RHODE ISLAND CONTRACT NO.2017-CB-070

**Horton Farm Bridge No. 472**

**NOTICE TO PROSPECTIVE BIDDERS**

ADDENDUM NO. 7    Prospective bidders and all concerned are hereby notified of the following changes in the Plans, Specifications, Proposal and Distribution of Quantities for this contract. These changes shall be incorporated in the Plans, Specifications, Proposal and Distribution of Quantities, and shall become an integral part of the Contract Documents.

5. VOLUME 1 SHEET 36A - PROPOSED BASIN GRADING PLAN

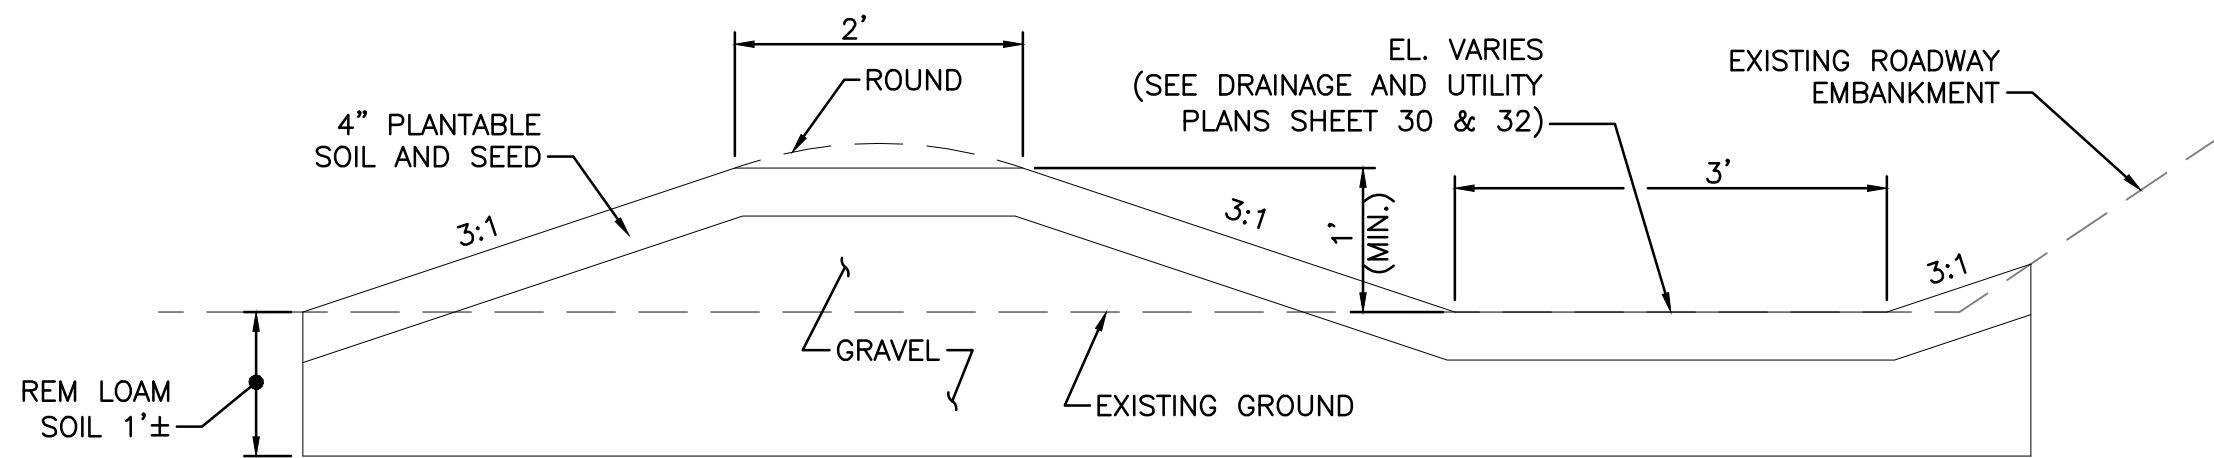
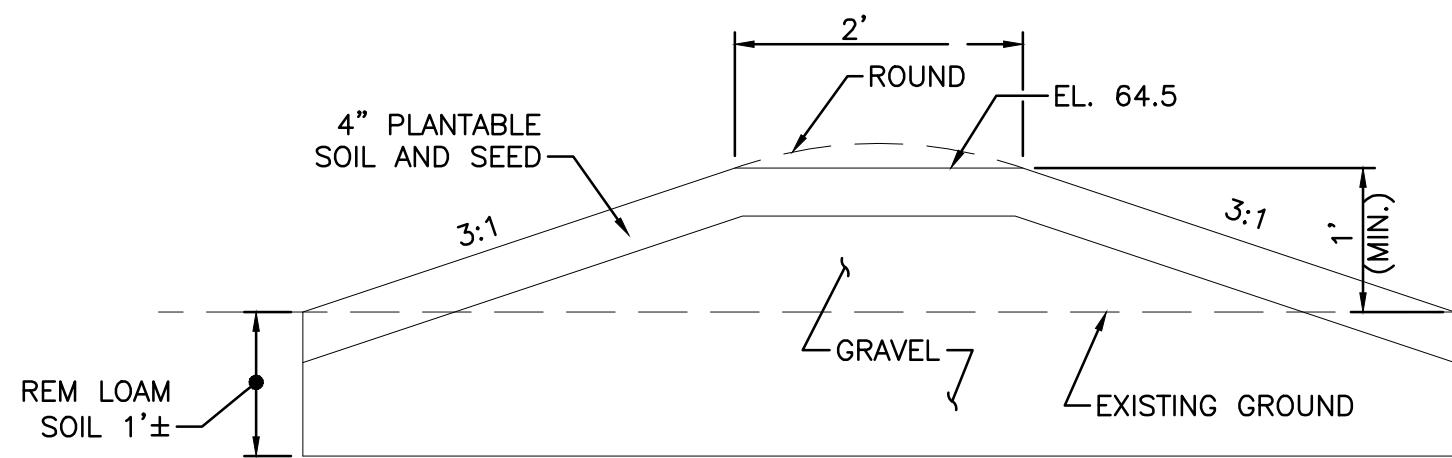
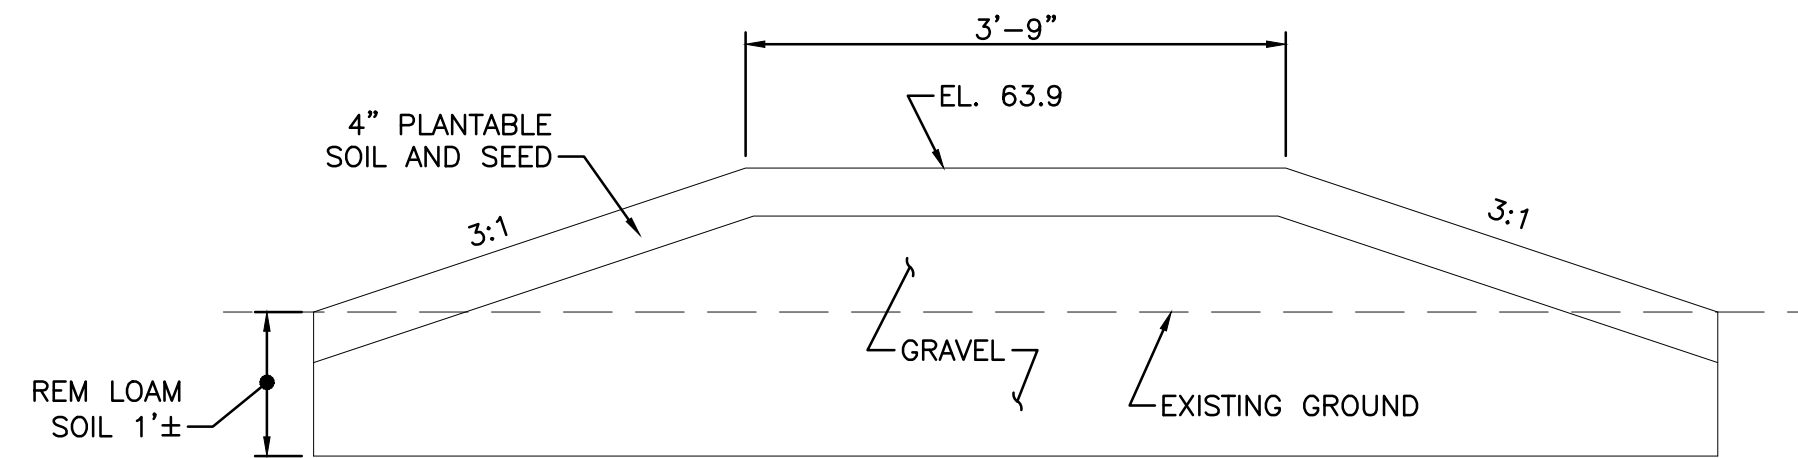
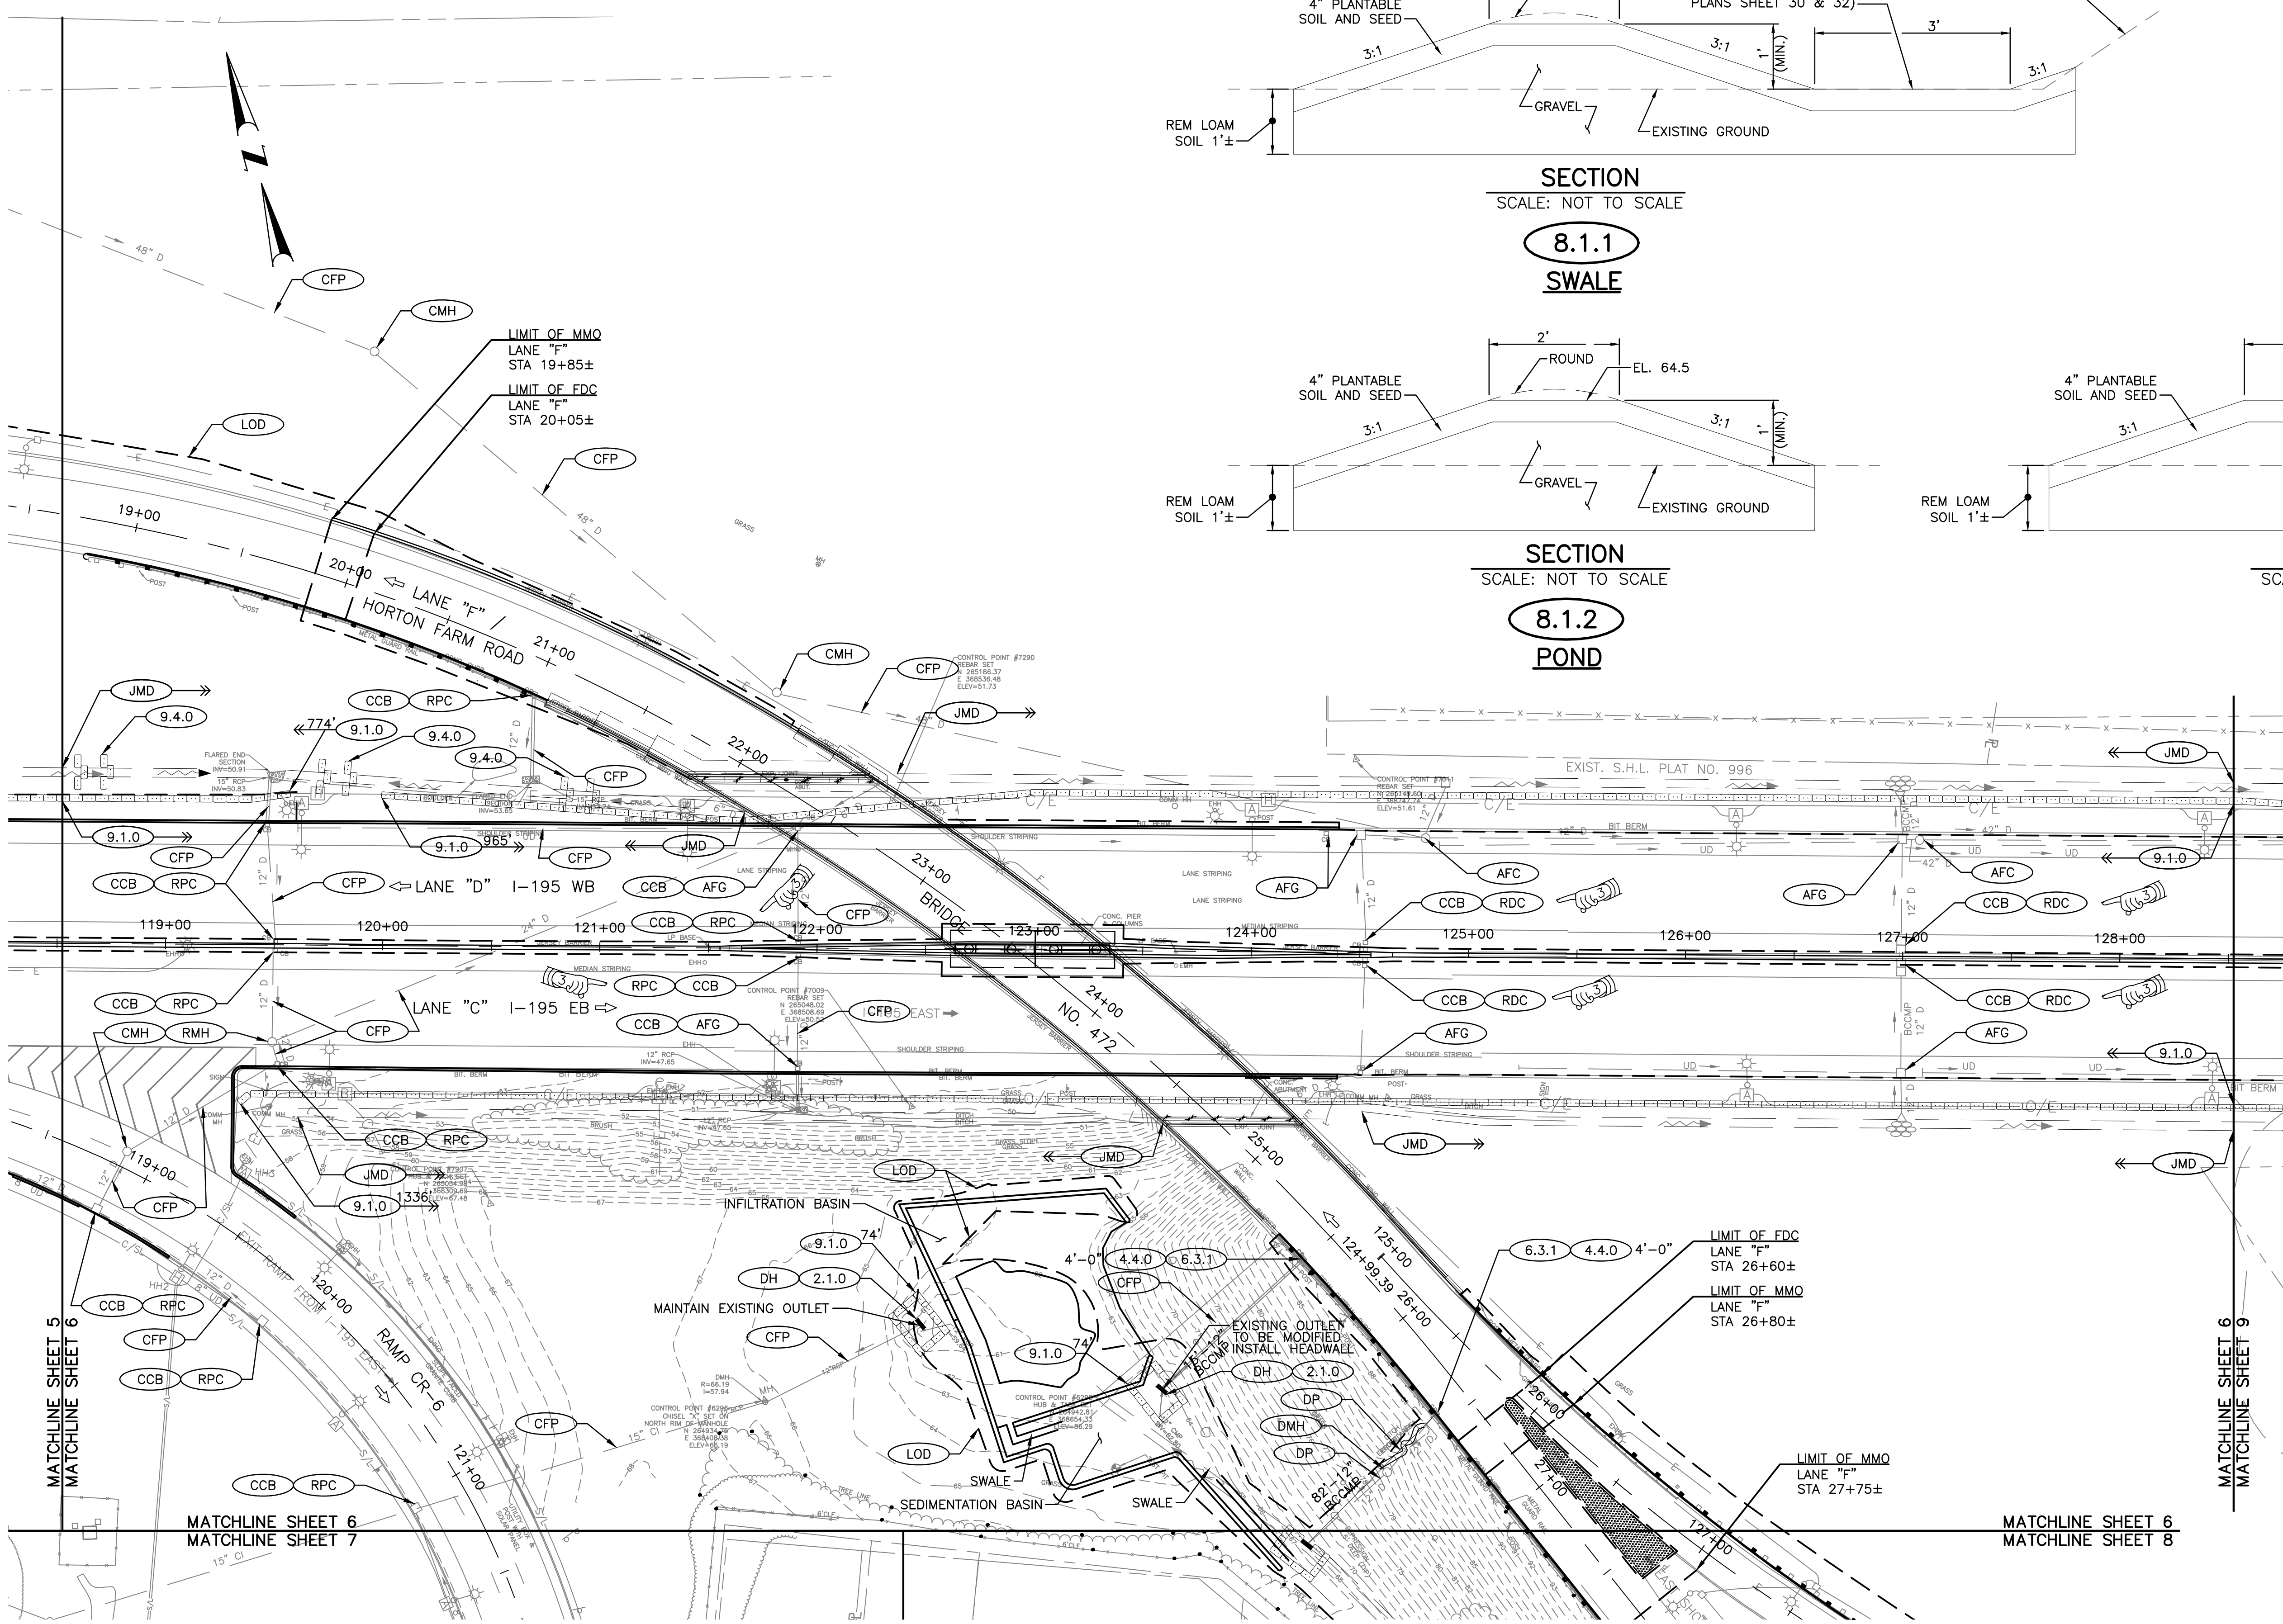
Insert Sheet 36A attached to this Addendum No. 7. The "Proposed Basin Grading Plan" has been added.
